Account Name: McNeil Company
 Homeowner Name: Schachne Residence
 Job Address: 13651 Cuming St

Room: Kitchen

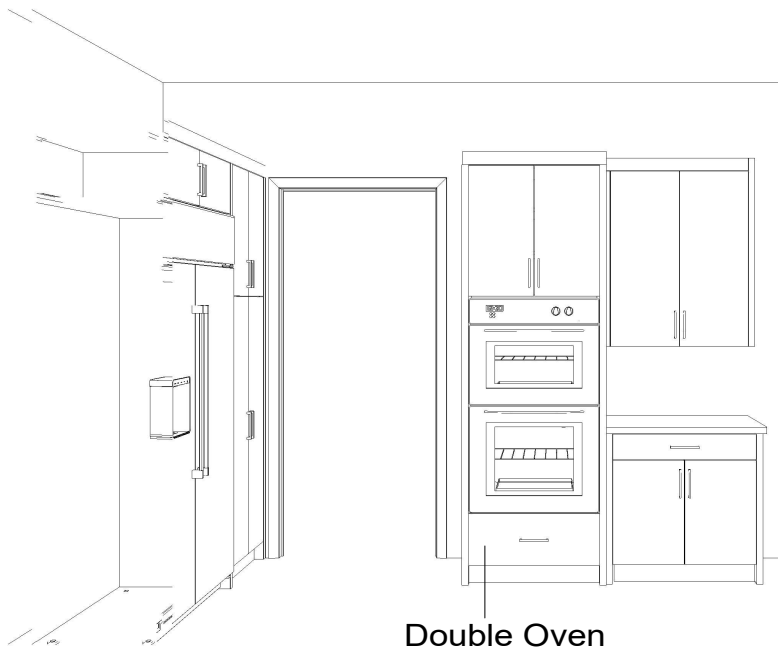
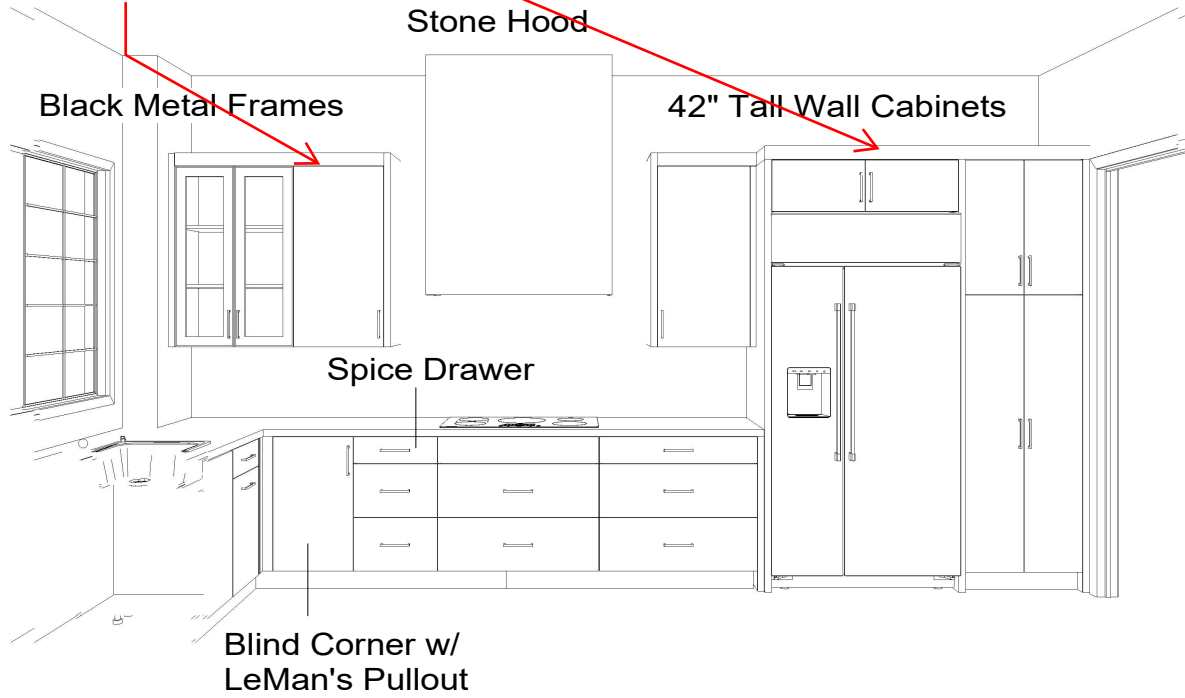
Recessed toekick
around entire island

top to band to be the
same size as the
sides - like the
showroom display -
all flush with doors

ok *cannot miter trim at corners*

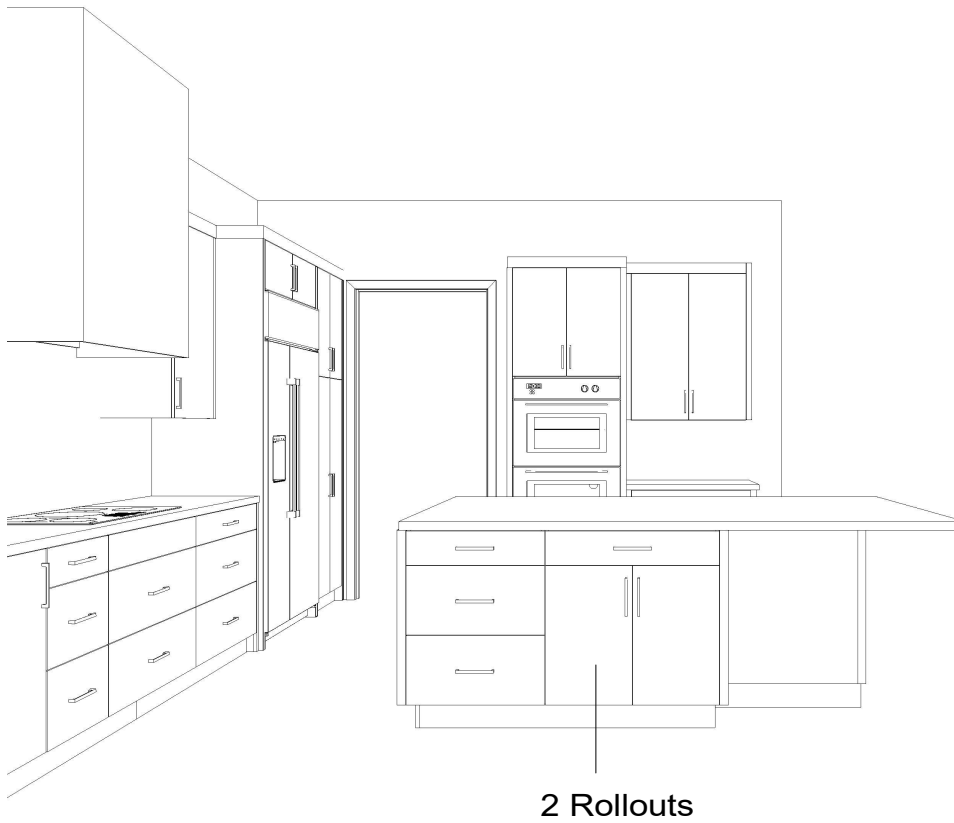
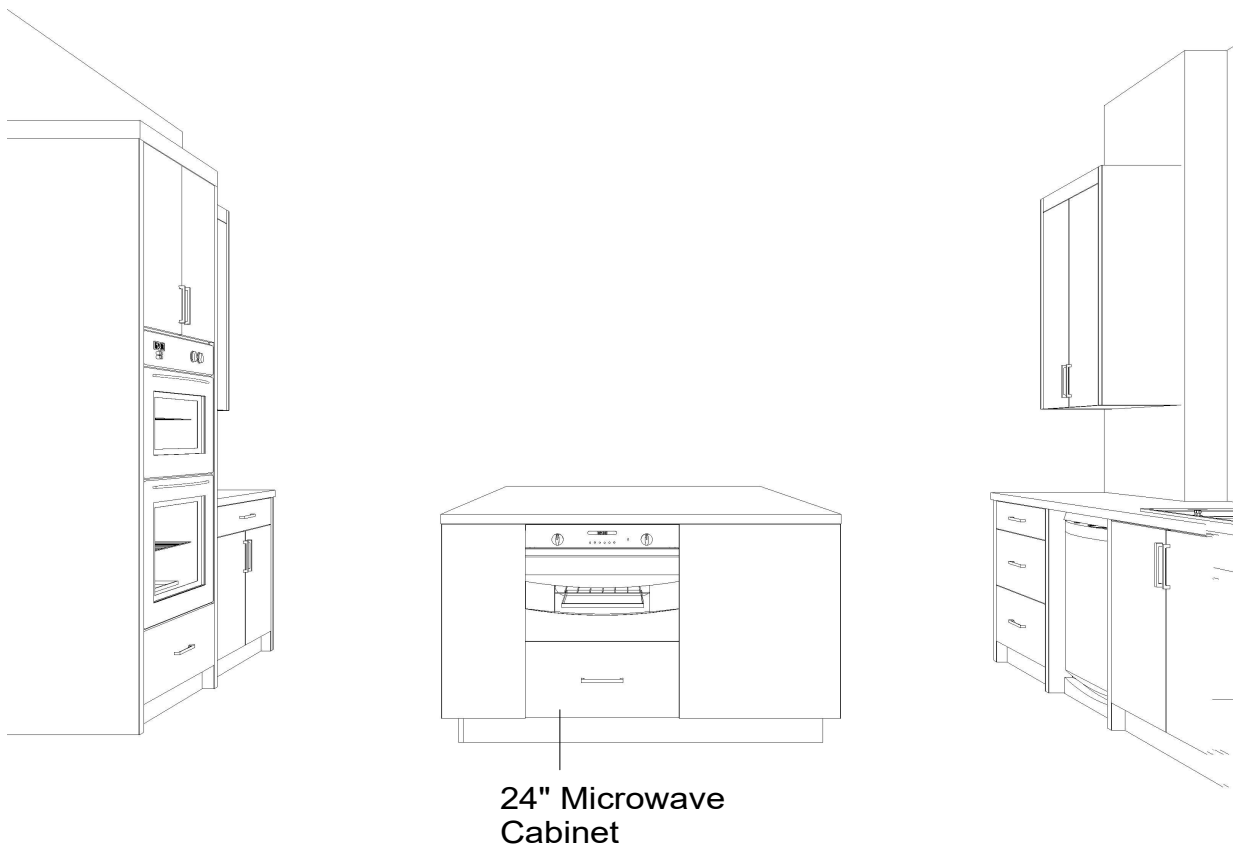
top to band to be the same size as the sides - like the showroom display

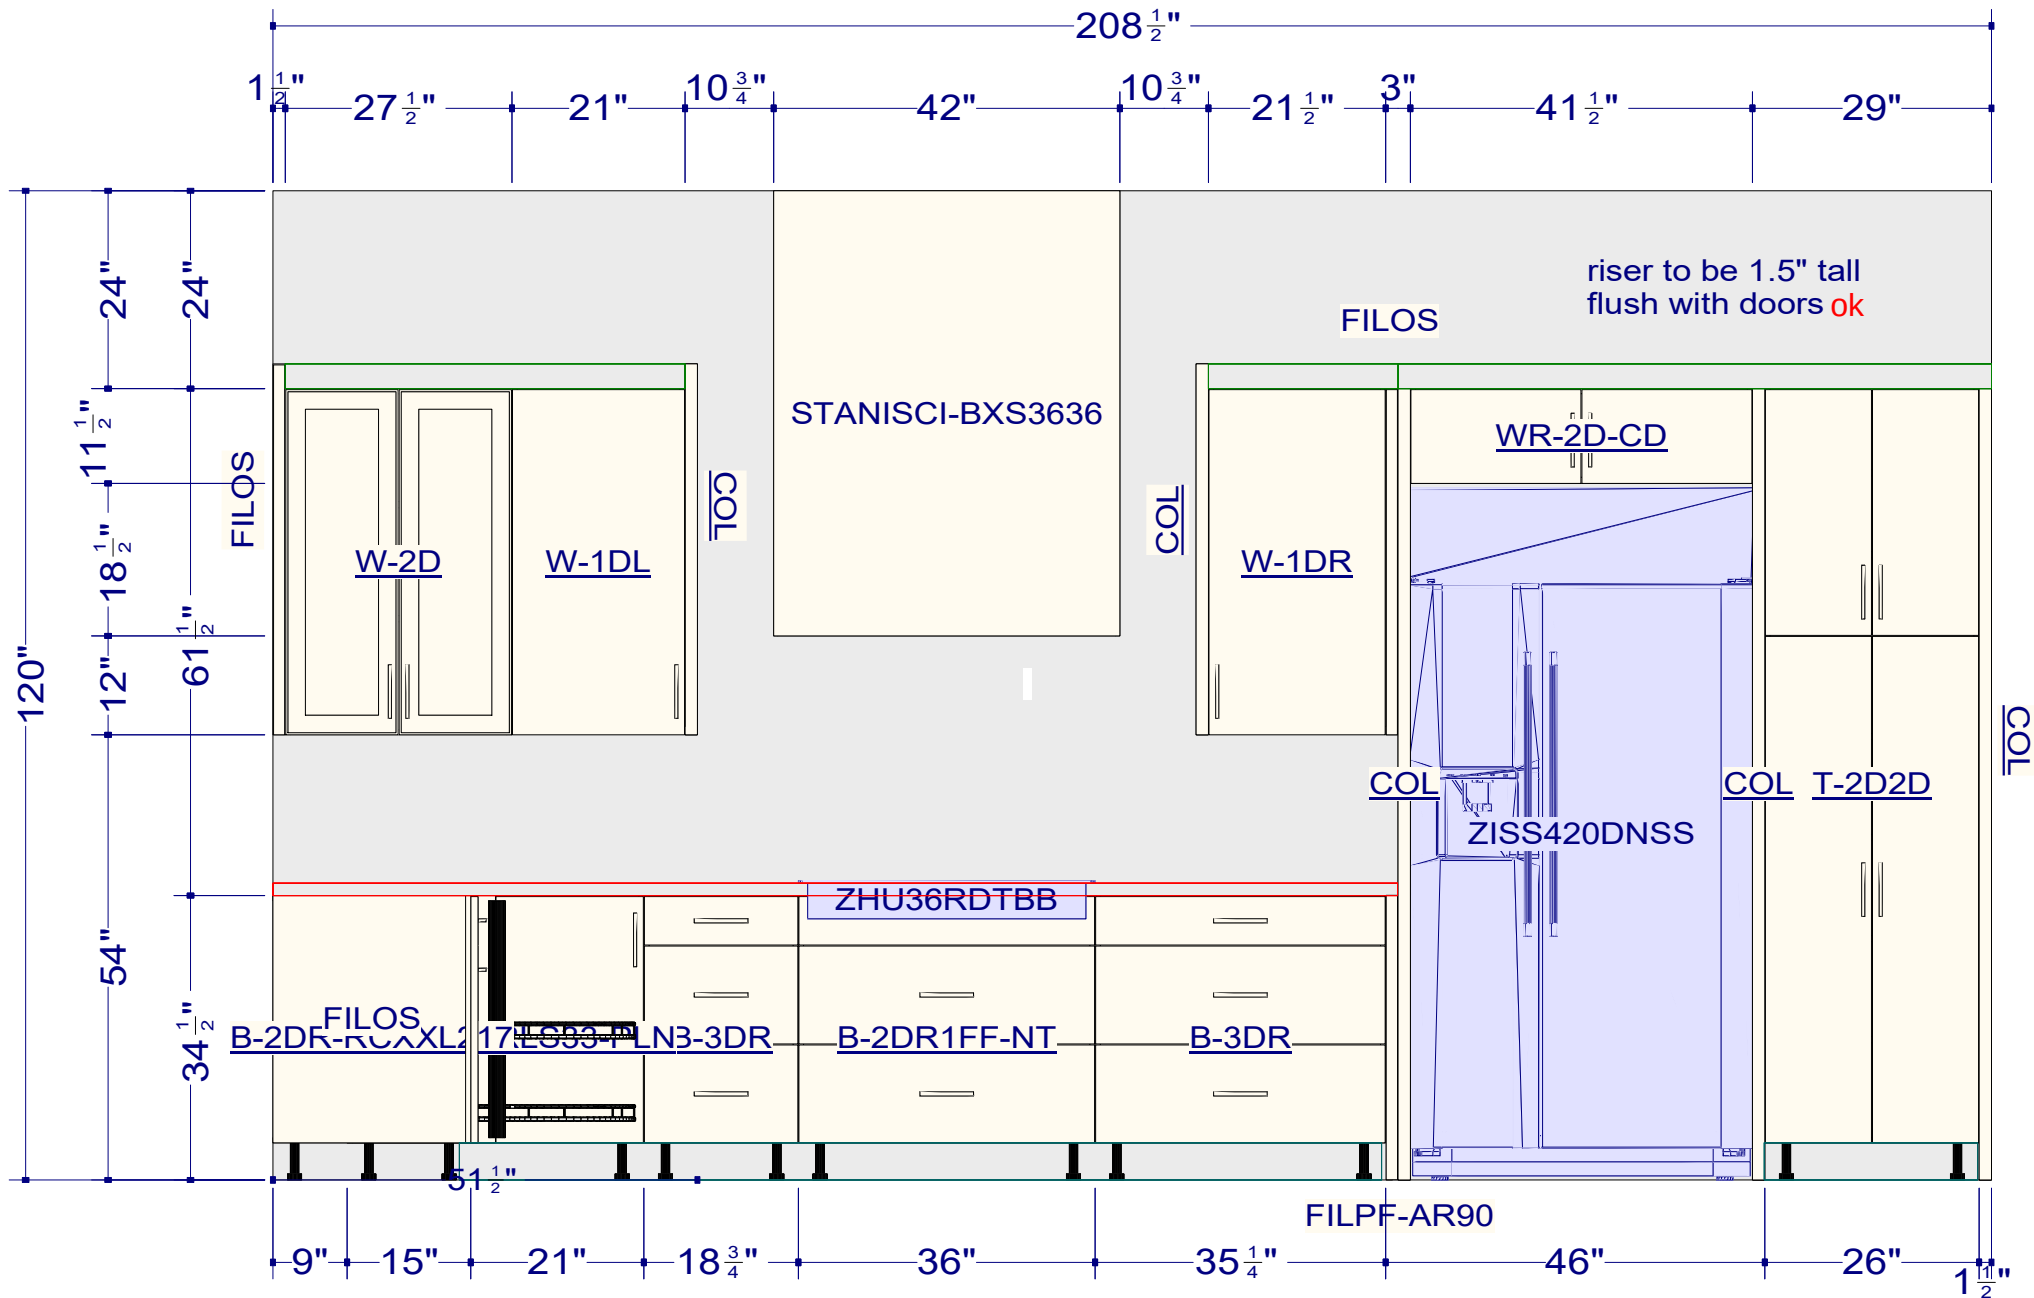
include steel supports
 for overhang

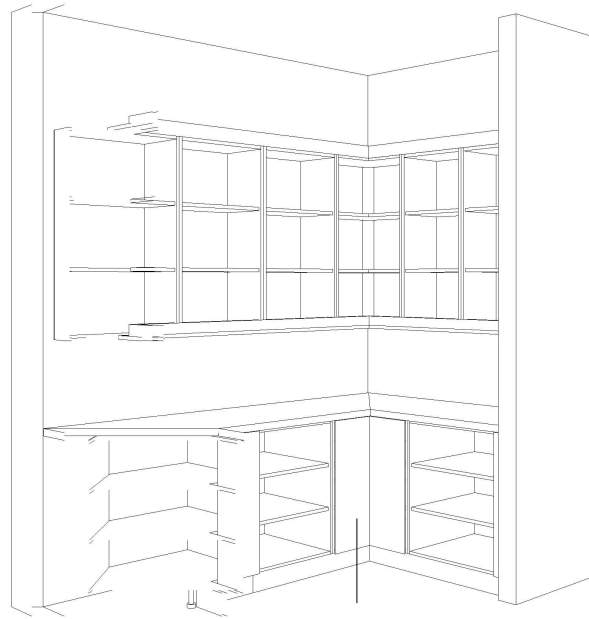
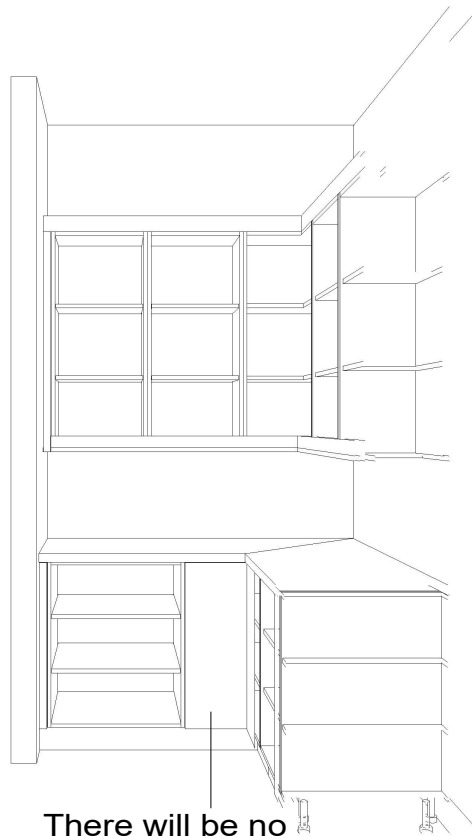
There will be no
doors on this cabinet

There will be no
doors on this cabinet

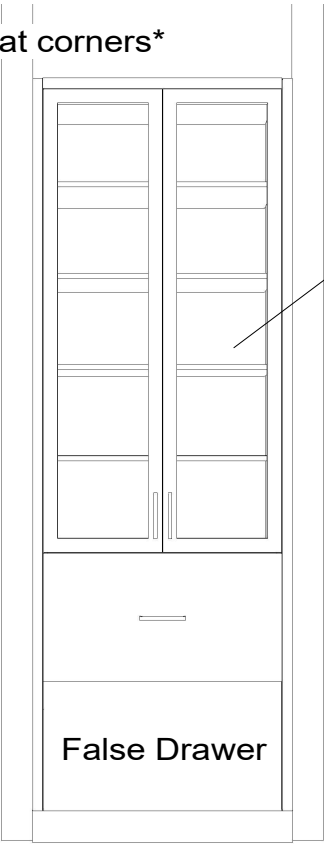
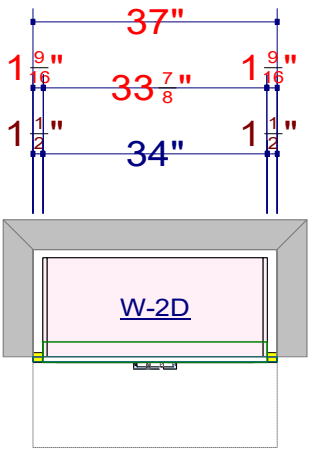
cannot miter trim at corners

Room: Great Room

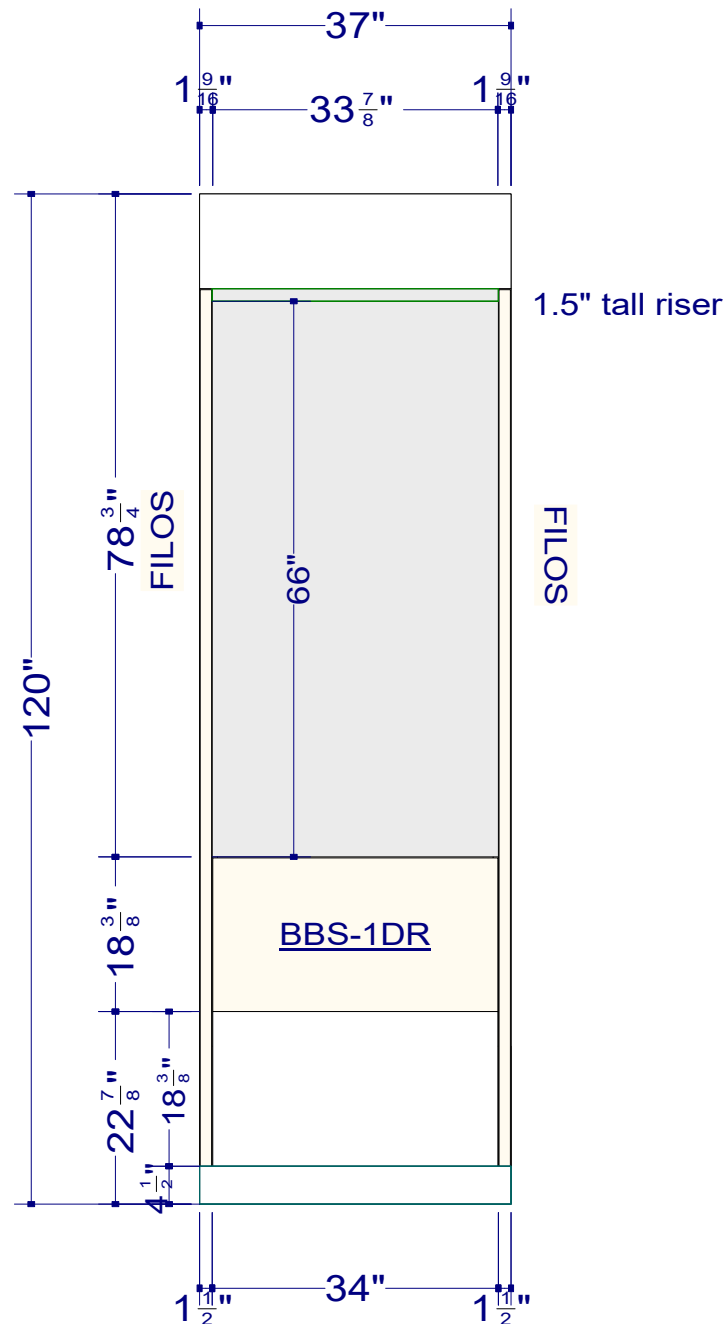
Build platform up 4.125"
Attach 3/4" material to wall
at floor as "toe kick".
Edgeband raw end. Fix
loose drawer front above it.
